EXTRACTS FOR DPI-WATER

2. RESPONSES TO ISSUES RAISED ABOUT THE AMENDED PROJECT

Figure 2.16.1 Proposed Groundwater Monitoring Bores

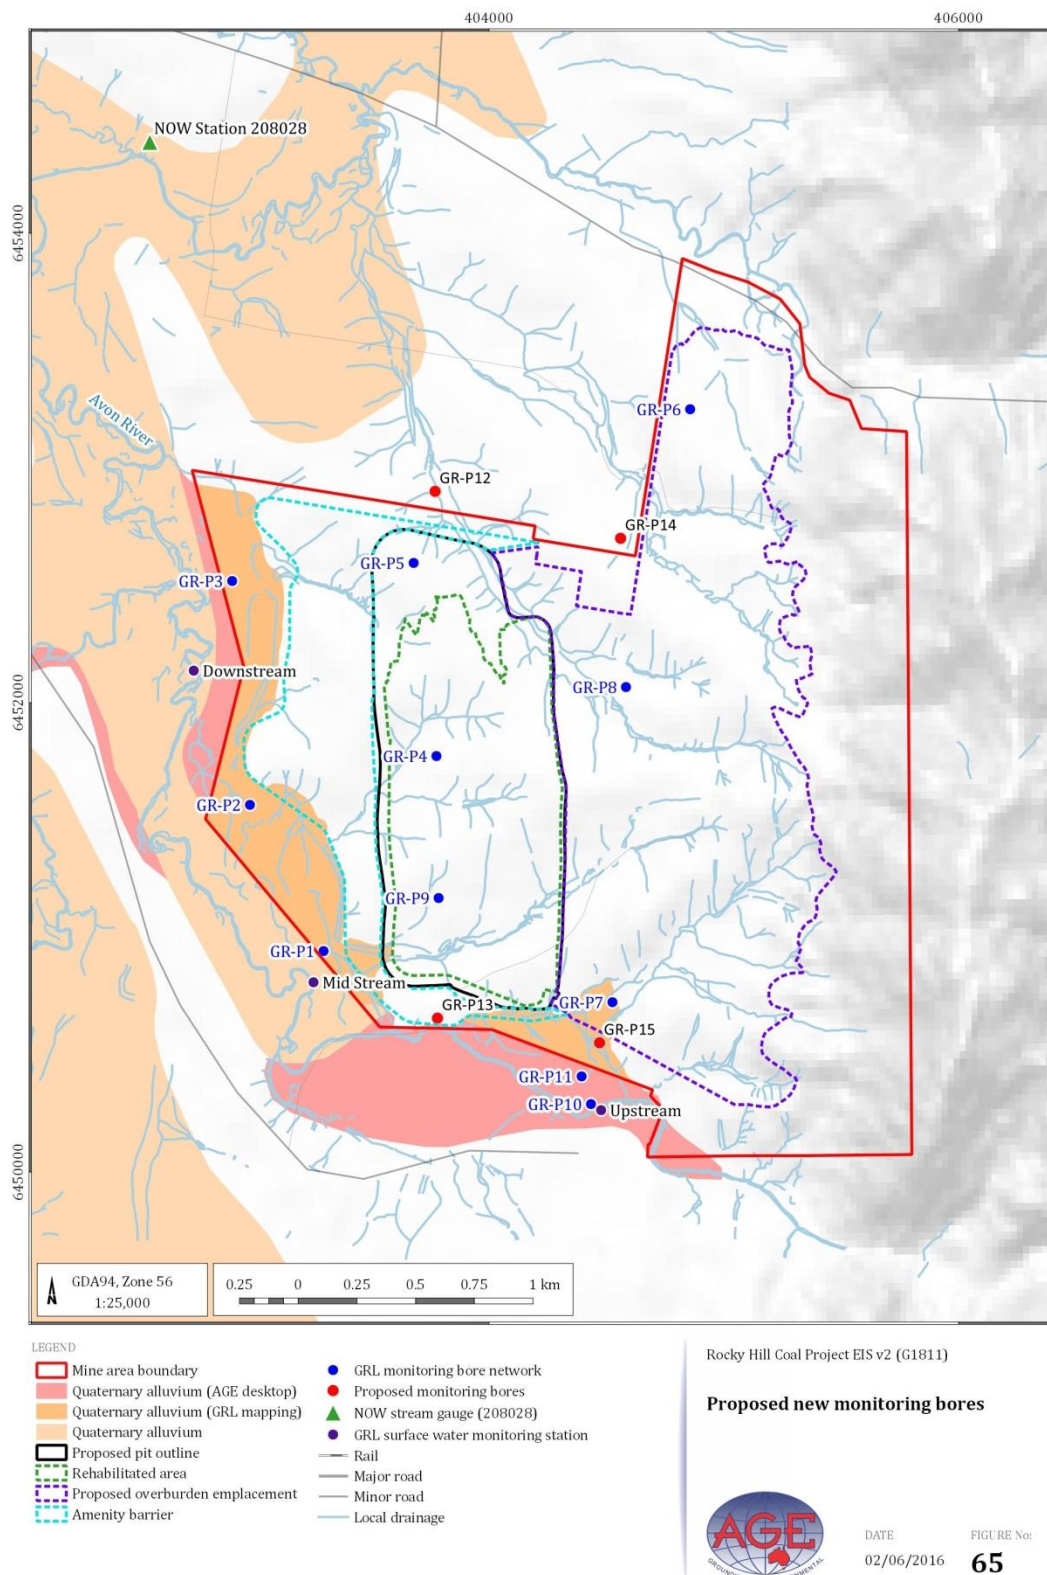
In addition to proposed monitoring the proponent should include detailed monitoring in the proposed "Water Management Plan" within the area of the intersection of the main pit and the alluvium. Should water quality levels exceed threshold values, and this is determined to be a long term trend, mitigation through the installation of a Low Permeability Barrier wall would be required.

A Water Management Plan would be prepared for the mine after development consent is granted. The existing monitoring bores GR-P1, P2, P3, P10 and P11 (see **Figure 2.16.1**), which would remain unaffected by mining activity and accessible throughout the life of the amended Project, would serve to monitor for any drawdown in the alluvium beyond what is predicted. The monitoring of groundwater levels over groundwater quality is preferred in this instance, as a groundwater level response would be observed well before a water quality change.

If the observed drawdown is substantially greater in the alluvium than what is predicted, consideration would be given to installing a low permeability barrier to minimise direct groundwater inflow from the Quaternary alluvium to the open pits. However, the reduction in seepage mitigated through such a barrier is highly likely to be small and relatively insignificant when compared to the overall seepage to the open cut pits. The volume of groundwater potentially saved through the installation of a barrier wall is likely to be comparable to the water supply requirements during construction of such a barrier and therefore the feasibility and benefits of the installation of such a barrier would need to be carefully considered prior to implementation.

Figure 2.16.5 Licence Surplus

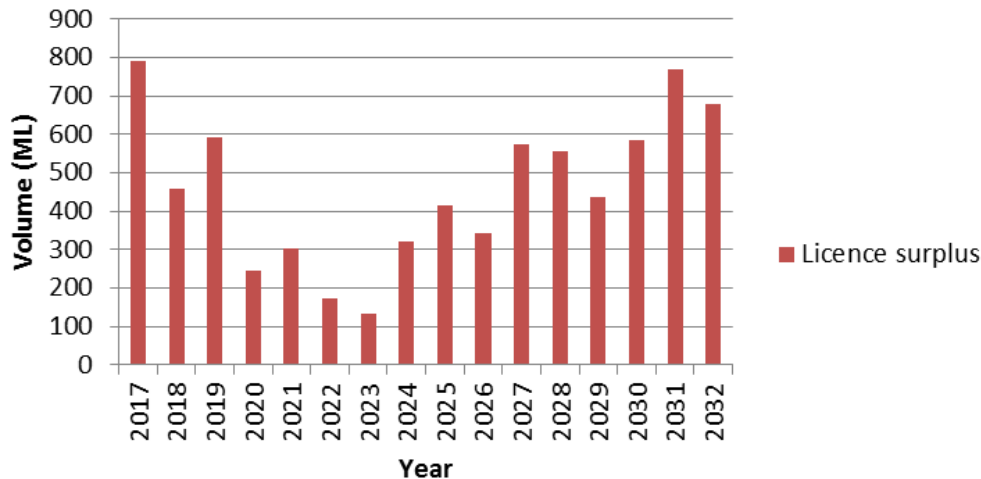
The proponent has not sufficiently demonstrated ability to obtain sufficient groundwater entitlement to account for a maximum take of 1100ML/yr. The proponent should provide further information or modification to reduce the take of water. This should include an analysis of groundwater entitlement requirements already approved under Yancoal's other operations (including timing of maximum predicted take) as well as analysis around the carryover rules of the Water Sharing Plan.

The proponent should obtain a minimum of 1100 unit shares in the Water Sharing Plan for the Gloucester Basin Groundwater Source to offset inflows to the mine pit prior to commencement.

When the predicted annual Permian groundwater inflows for the amended Project is included (source: EIS Figure 4.38) there would still likely be a surplus of water entitlements in the system (see **Figure 2.16.5**).

It is GRL's intention to access water licence entitlements⁴ which are in excess of Yancoal's demand in any year from Yancoal in accordance with the agreement between the two companies. The entitlements purchased would reflect the revised predicted inflows within the Rocky Hill Mine Area from the Permian groundwater source obtained through ongoing groundwater monitoring and modelling pursuant to the Water Management Plan, particularly given that AGE Consultants maintains that the predicted inflows derived through the modelling for the amended Project and listed in **Table 2.16.4** are conservative. The model would be reviewed and updated as necessary to reflect measured inflows so that, at all times sufficient entitlements are held.

Figure 2.29.1 Revised Strahler Classifications

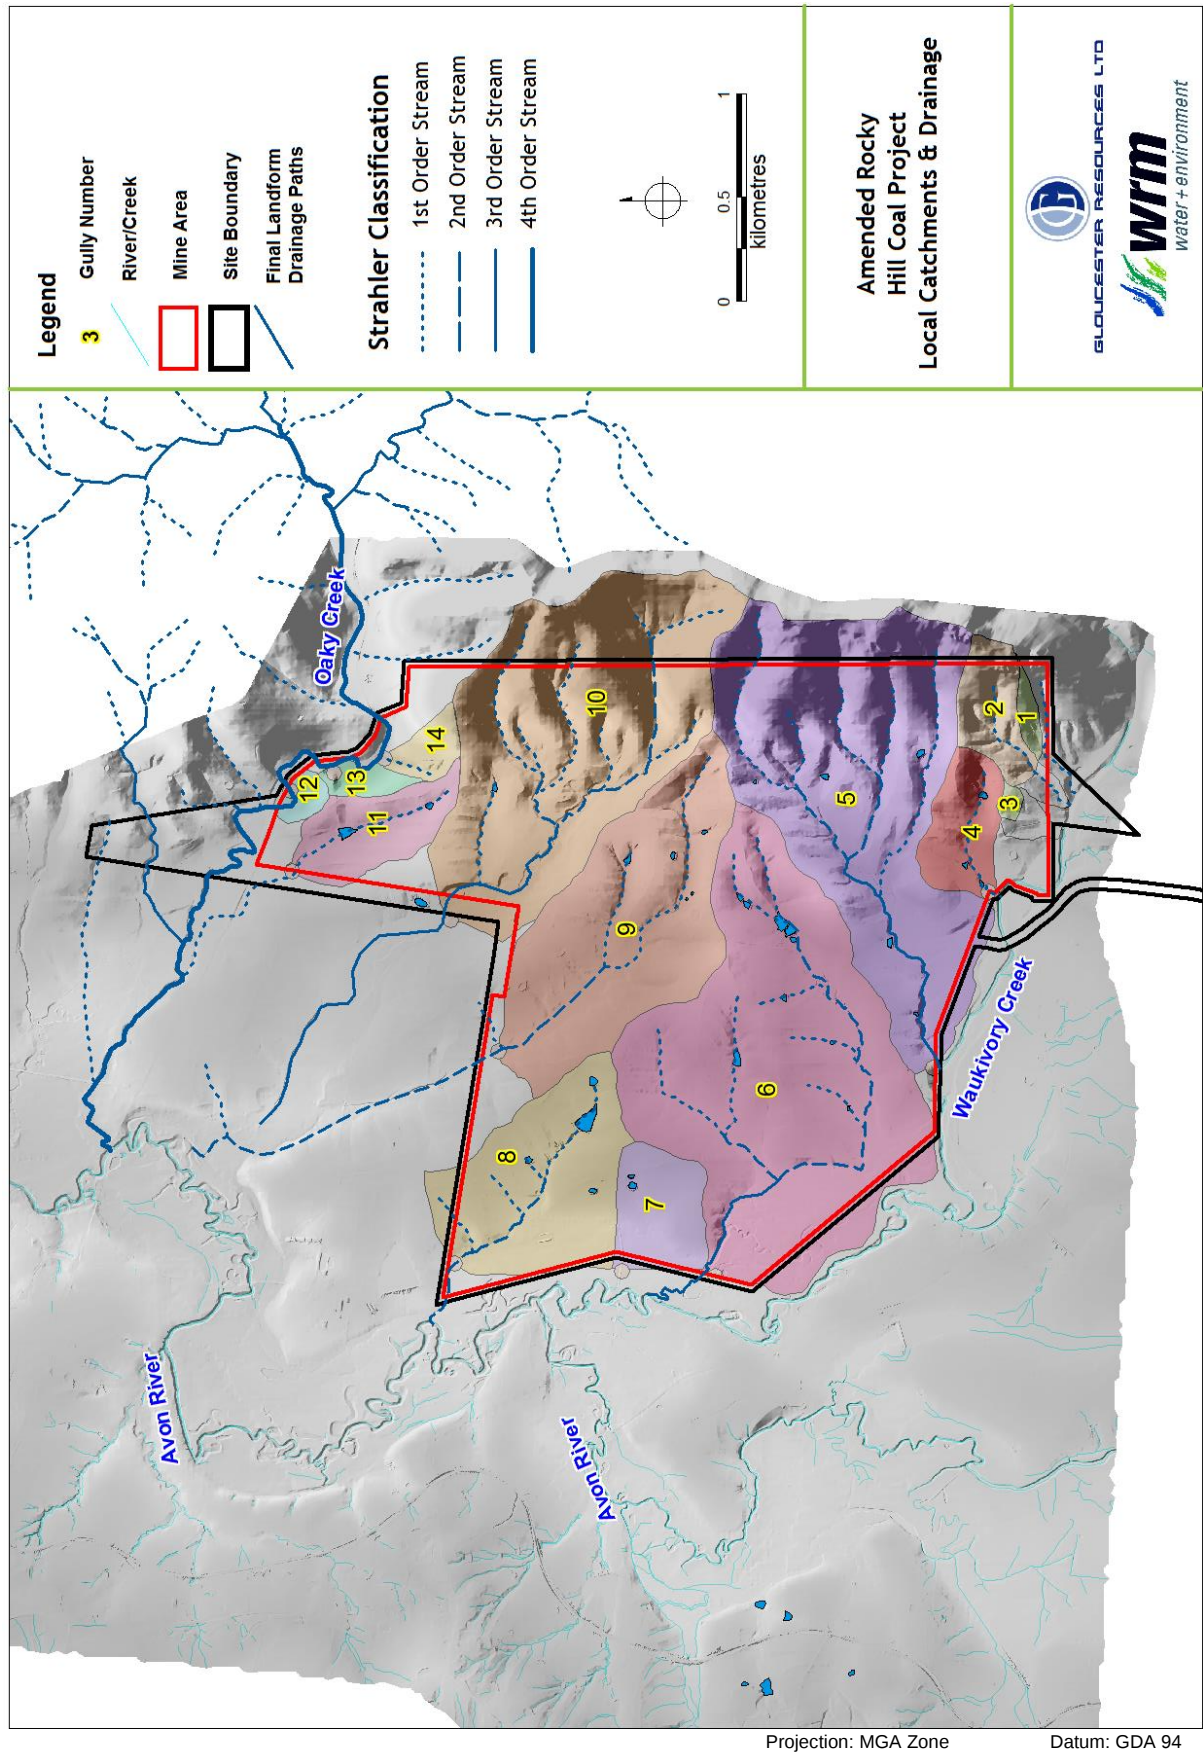
The EIS incorrectly identifies Oaky Creek from the mine area to its confluence with Avon River as a 3rd order stream, whereas at this location Oaky Creek is a 4th order stream. The proponent should amend the EIS to accurately reflect this stream order.

WRM agrees that Oaky Creek is a fourth order stream from its confluence with the Avon River, upstream to a point about 1.6km upstream of the mine area. Though this was correctly shown in the SWA (Figure 2.20), the text incorrectly referred to Oaky Creek as a third order stream.

Figure 2.29.1 shows the stream order map revised using the latest topographic maps available via the NSW Government Spatial Services' Six Map Viewer, which were not available when the SWA was originally prepared.

Figure 2.29.2 Comparison Plot of Gaugings and Latest Ratings

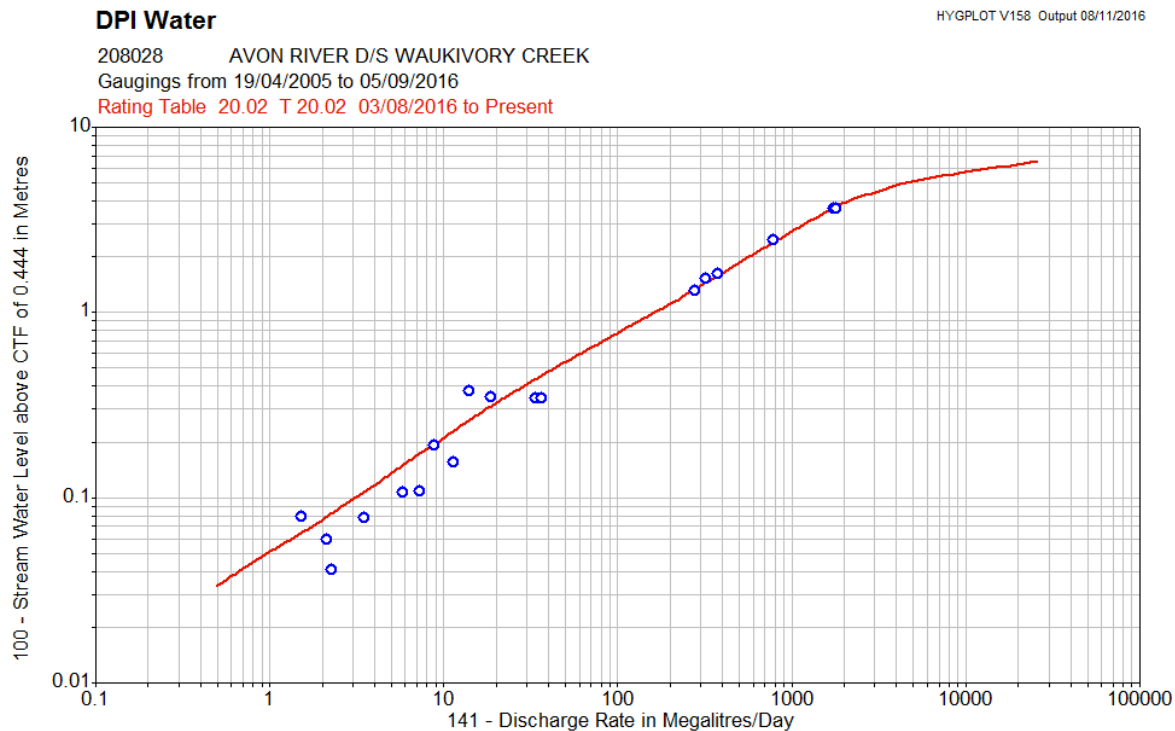
Total catchment losses in the Avon River associated with the project are predicted to result in an increase in cease to flow conditions from 13.9% of the time to 16.8% of the time. The EIS concludes that this could increase the likelihood that cease-to-pump requirements are invoked more frequently. The analysis of possible impacts on reduced flows on water users (including licensed and basic landholder right users) within the water source should be improved. The proponent should provide further detail on the impact on these users, including any reduction, mitigation or compensatory measures proposed.

The Department of Primary Industry – Water notes that 20 gaugings were undertaken at the Avon D/S Waukivory gauge between 19/04/2005 and 04/11/2016. The plot in **Figure 2.29.2** compares the rating curve to flow and water level measurements undertaken for the gaugings. The flow control comprises a rock bar/willow 200m downstream of the gauge. The cross-section was surveyed in 2009, and a check survey undertaken in December 2015.

Figure 2.29.2 shows the rating curve underestimates the gauged flow in six of the seven gaugings undertaken at flows between 1.5ML/day and 10ML/d. As there is no evidence to suggest either the cross-section survey or gaugings are unreliable, it seems unlikely that the flow record overestimates streamflow in low flows between 1.5ML/day and 10ML/day. In fact, it suggests that the flow record underestimates low flows at the gauge by as much as 1ML/day.

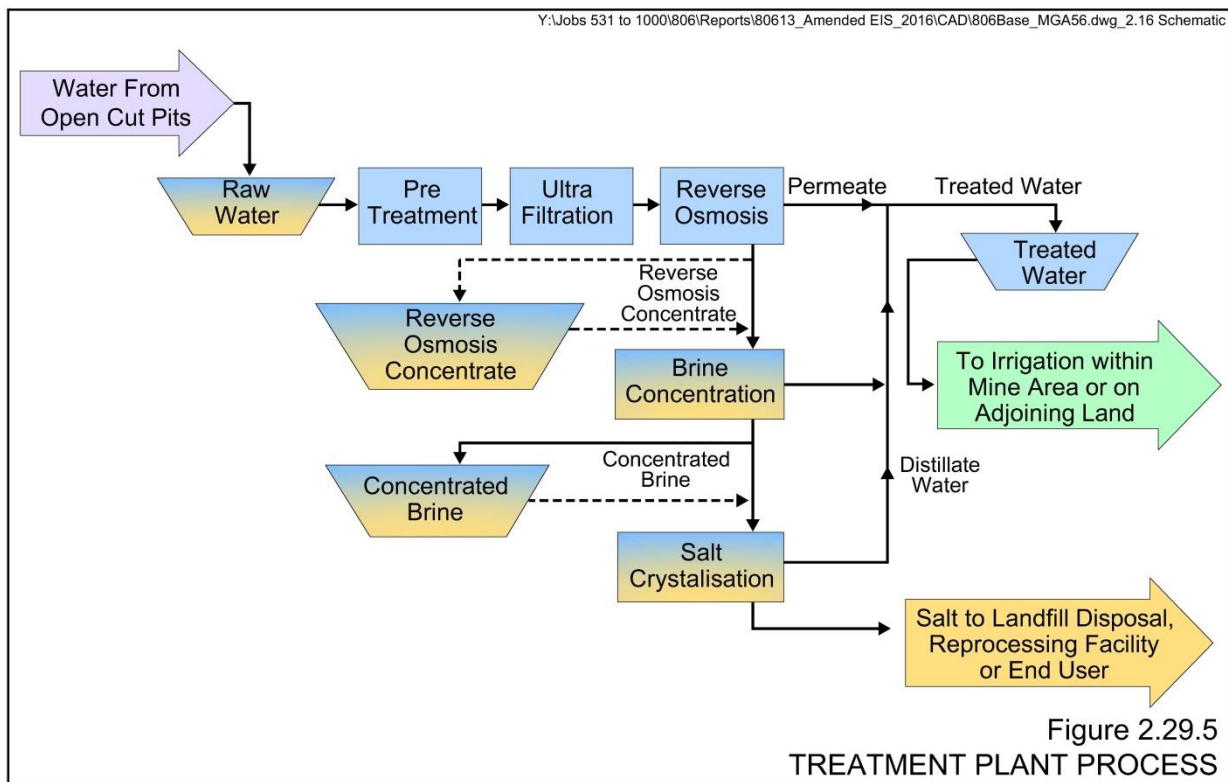
The proponent should provide further detail on the water treatment processes proposed for the water treatment plant to be installed in year 4 of the project, and the quality of treated water compared to water in the Avon River. This detail should outline why releases are only proposed for high flow conditions, with reference to the reduced water flow outlined above.

As noted in EIS Figure 2.16 (reproduced as **Figure 2.29.5**), the likely system proposed to treat the excess water within the saline water zone and its subsequent brine waste, would likely involve the following steps, as further described below.
